CORPS OF
ENGINEERS

Improved Analysis of
Costs and Benefits
Needed for
Sacramento Flood
Protection Project

Highlights of [GAO-04-30](#), a report to congressional requesters

This is the Department of Defense (DOD) response to the General Accounting Office (GAO) draft report, "CORPS OF ENGINEERS: Improved Analysis of Costs and Benefits Needed for Sacramento Flood Protection Project," dated August 19, 2003 (GAO Code 360273/GAO-03-1055)."

Figure 3: Location of the Fremont Weir and the Yolo Bypass

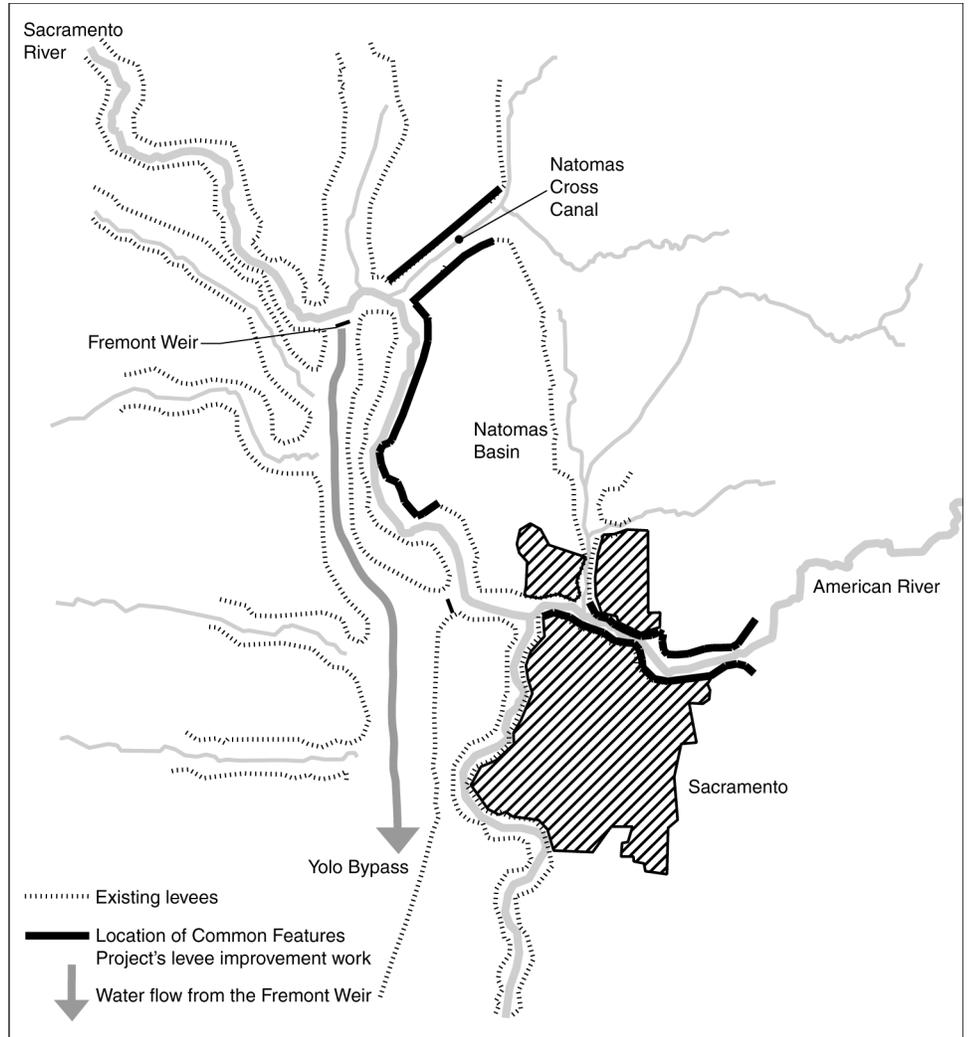
Given that the Natomas Basin levee improvements will cost significantly more than originally estimated and no construction has yet begun, identifying and evaluating alternative flood protection measures could result in cost savings. For example, one possible alternative method for flood protection identified by the Sacramento Area Flood Control Agency,⁸ as well as the Corps, involves lowering the water level in the Sacramento River during floods by diverting water through the Fremont Weir and into the Yolo Bypass, which is located at a point just before where the Sacramento River flows past the Natomas Basin.⁹ The Fremont Weir is a low dam that controls the movement of large volumes of floodwater from the Sacramento River by diverting it into the Yolo Bypass. The Yolo Bypass is a continuous, 40-mile open space corridor that is protected from urban development pressure by flood easements. (See fig. 3.)

Lowering the water level in the Sacramento River as it passes the Natomas Basin could, among other things, improve the reliability of the Natomas Basin levees and may provide more cost-effective flood protection than the current Natomas Basin levee improvement plan. However, as of June 2003, the Corps had not yet analyzed the costs and benefits of modifying the weir and the bypass or any other alternative method for Natomas Basin flood protection.

- analyze the costs and benefits of alternatives to the current levee improvement plan and identify the flood protection plan that provides the greatest net benefits and
- submit a report to Congress that includes a cost estimate for all of the planned Natomas Basin work, and wait until Congress authorizes funding that is based on the report before beginning construction of any Natomas Basin levee improvements.

DOD RESPONSE: CONCUR. The Corps acknowledges that in light of the potential for substantial increases in project costs, based on construction experience with the American River levee improvements, there is a need to investigate a wider array of alternatives for providing flood protection for the Natomas basin. Corps policy requires a reformulation of the authorized project. The ability of the authorized engineering features to provide outputs intended by Congress will be evaluated, as will all other reasonable alternatives.
